Type Coffee Vending Machine	Model 9100 - 95	N° T.I. 03 - 2019
Serial Number See page 2/2	Subject IMPROVEMENTS OF SINGLE R&G CANISTER	ISSUED FOR (X) Action Information X

Type Coffee Vending Machine	Model 9100 - 95	N° T.I. 03 - 2019
Serial Number See page 2/2	Subject IMPROVEMENTS OF SINGLE R&G CANISTER	ISSUED FOR (X) Action Information X

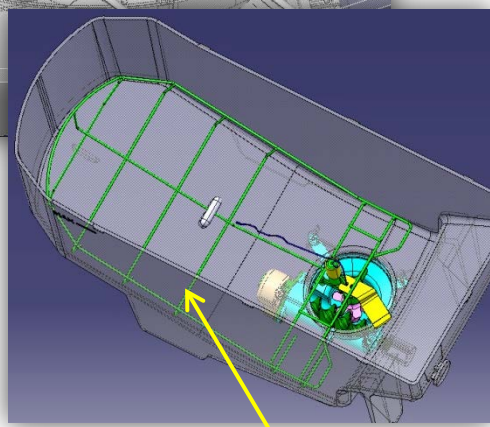
The **emptying** of *R&G canister* has been improved by the following modifications:

- **new** parts: **1.** lever – **2.** metal beater wire – **3.** washer
- **old** parts: **1.** beater spring – **2.** safety washer

New position for *single R&G coffee scraper stop*
The stop is **now** closer to the motor to reduce the vertical movement of the *single R&G coffee scraper*

Single R&G coffee scraper
Not changed

Lever for R&G canister
Spare code: **261993**

Metal beater wire
Spare code: **261994**

Washer 4x12 Inox
Spare code: **255491**

4

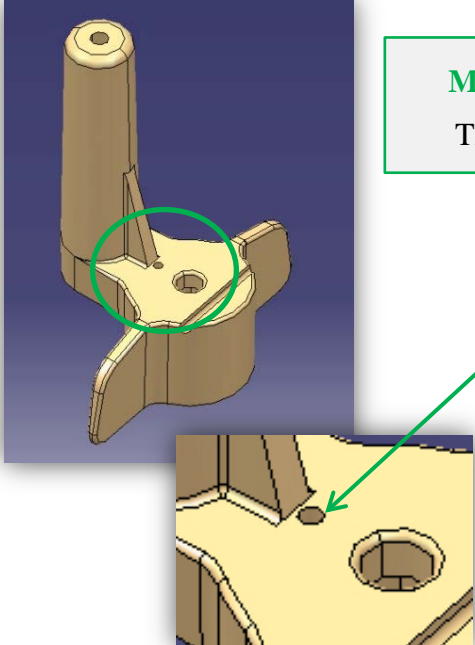
Modified eccentric **support** for *scraper*
The spare code is not changed: **260646**

A **hole** has been added to fix the **beater** (part **2**)

For machines previous to above **S/N**, to get the improvements described it's necessary to replace **old** parts **1** and **2** with:

- the **new** parts **1**, **2**, **3** and the **modified** part **4**
- **Important note:** the canister capacity **reducer** (spare code: **259794**) should not be used with **new** solution.
